LAWRENCE HISTORIC RESOURCES COMMISSION
AGENDA FOR **APRIL 18, 2019**
CITY HALL, 6 E 6TH STREET
6:00 PM

**LAWRENCE HISTORIC RESOURCES
ADMINISTRATIVE REVIEW
STAFF REPORT**

TO: Historic Resources Commission
FROM: Kyle Kobe, Planner I
DATE: April 18, 2019
RE: Item No. 8: DR-19-00092 1009 New Jersey Street deferred from March 21, 2019 Agenda

SHEET TITLE
**EXTERIOR
ELEVATIONS**

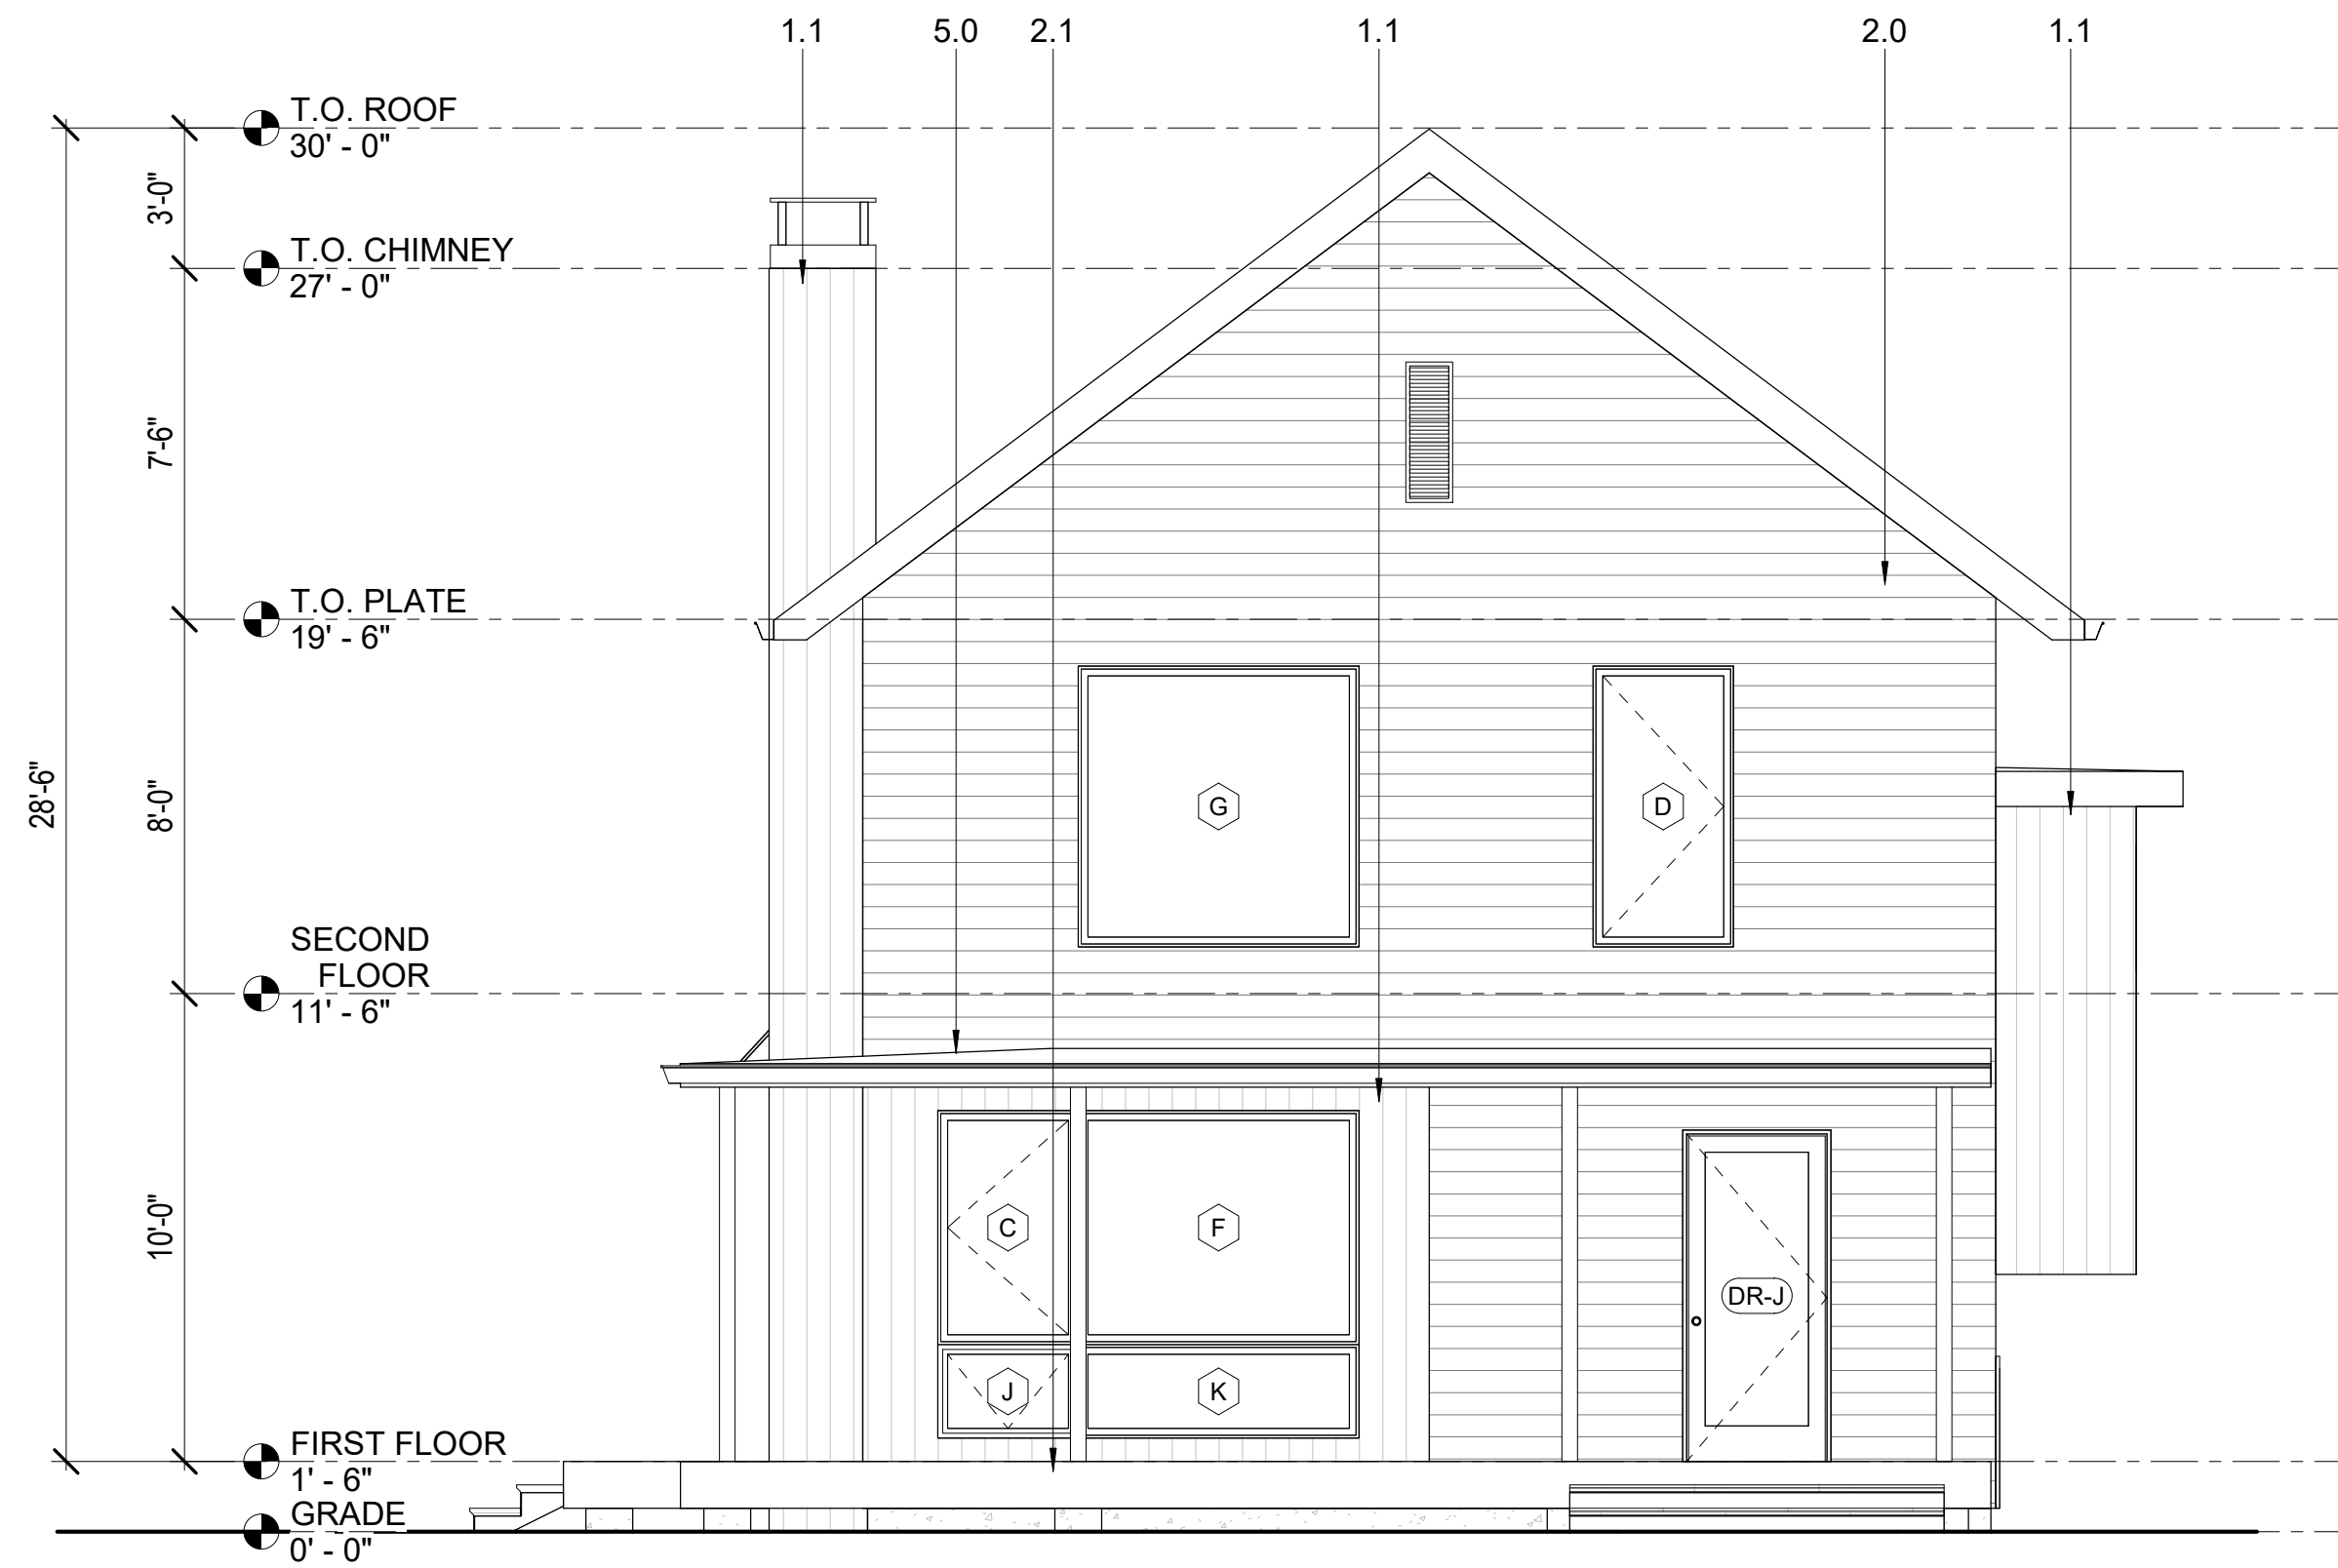
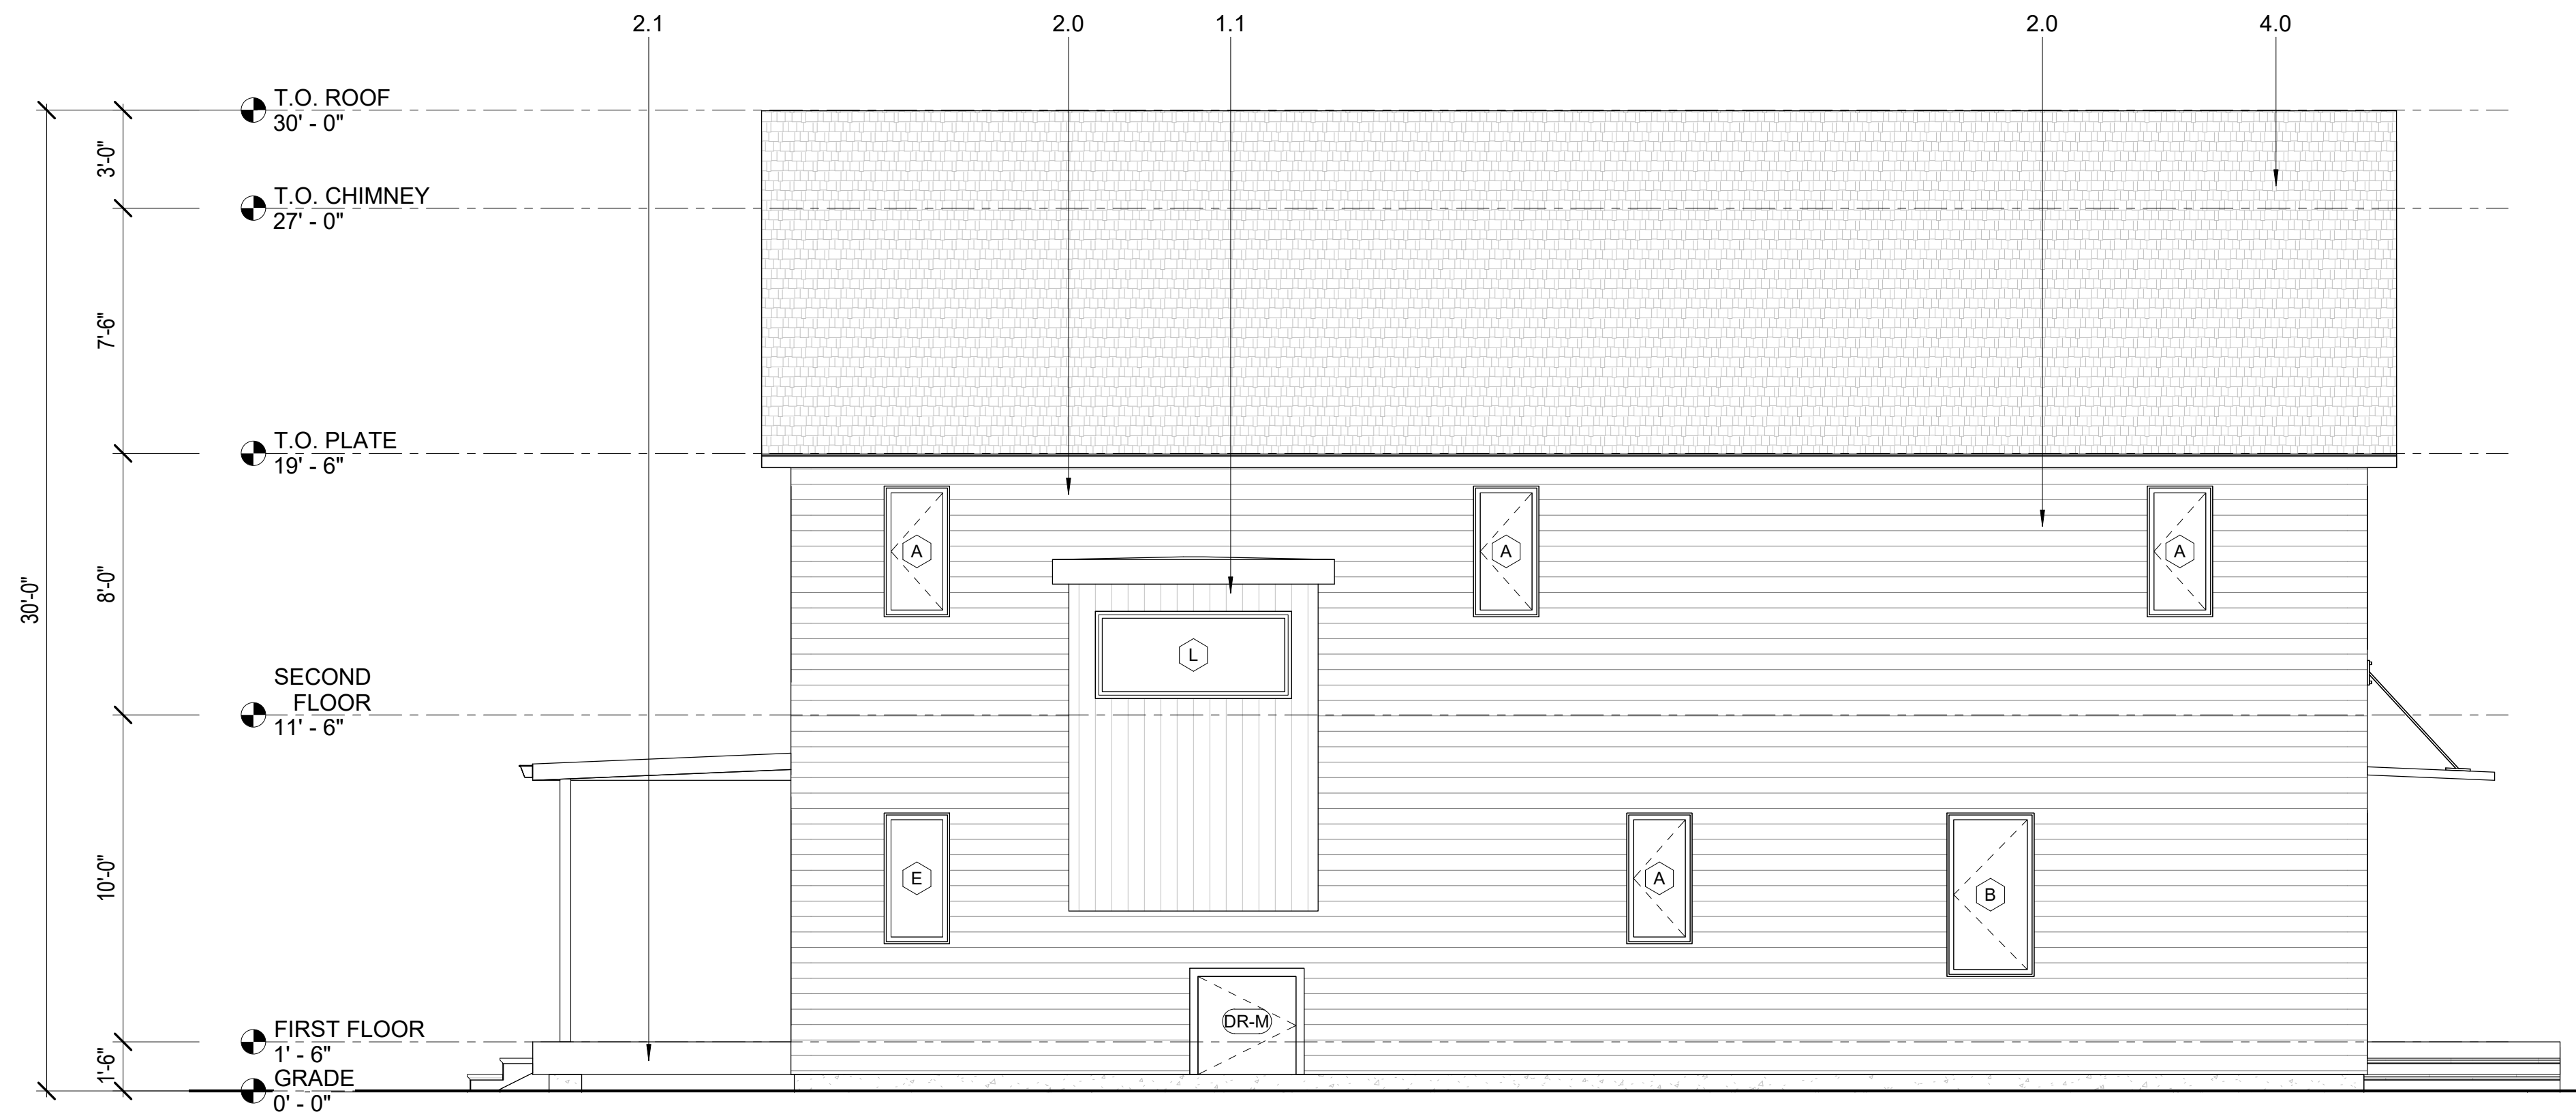
The ARC requested the applicant submit revised drawings showing the agreed upon changes. The applicant submitted revised drawings on April 9, 2019. The drawings showed the use of 4 inch by 4 inch columns. The applicant also requested to use vinyl windows due to cost.

Staff recommends the commission review the revised plans attached to this memo and make a final determination on the column size and the use of vinyl windows in their deliberation on the project. If the commission votes to approve the project, staff recommends the commission direct staff to review any subsequent minor alterations to
